SERVICE BULLETIN

REPLACEMENT OF OIL PUMP ASSY. OR OIL PUMP SHAFT ASSY. ON ROTAX® ENGINE TYPE 912 A (SERIES) SB-912-032

MANDATORY

Bild / Fig. 1

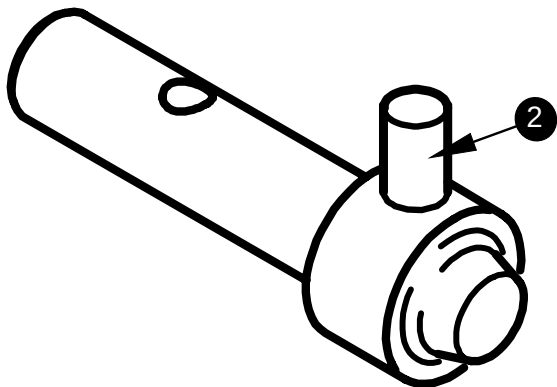
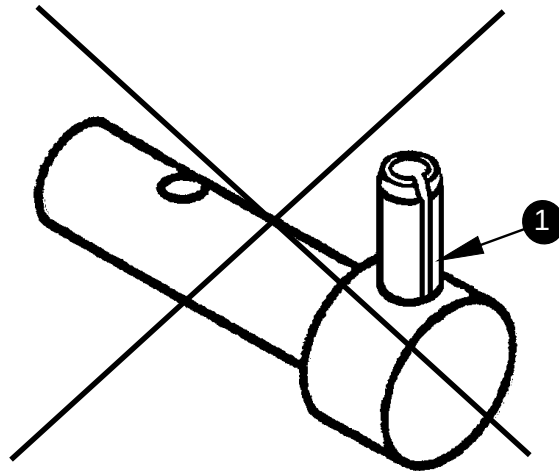
In isolated cases traces of wear on the dowel sleeve of the oil pump shaft were noticed.

- Remove oil pump assy.
- Check if solid drive pin 5x26 (1) is installed. If the solid drive pin is already installed, the oil pump must be inspected for proper condition and oil pump assy. has to be reinstalled.

- Remove oil pump.
- Inspect oil pump for proper condition.
- Remove oil pump shaft with dowel sleeve 5x28 (1) and install oil pump shaft with solid drive pin 5x26 (2) p/n 837 129.
- Install oil pump.

neu / new

Ölpumpenwelle kpl. TNr. 837 129 mit eingepreßtem
Kerbstift /
oil pump shaft assy. p/n 837 129 with solid drive pin

alt / old

Ölpumpenwelle kpl. mit Spannhülse /
oil pump shaft assy. with dowel sleeve

◆ NOTE: The new oil pump shaft p/n 837 129 is only supplied with solid drive pin.
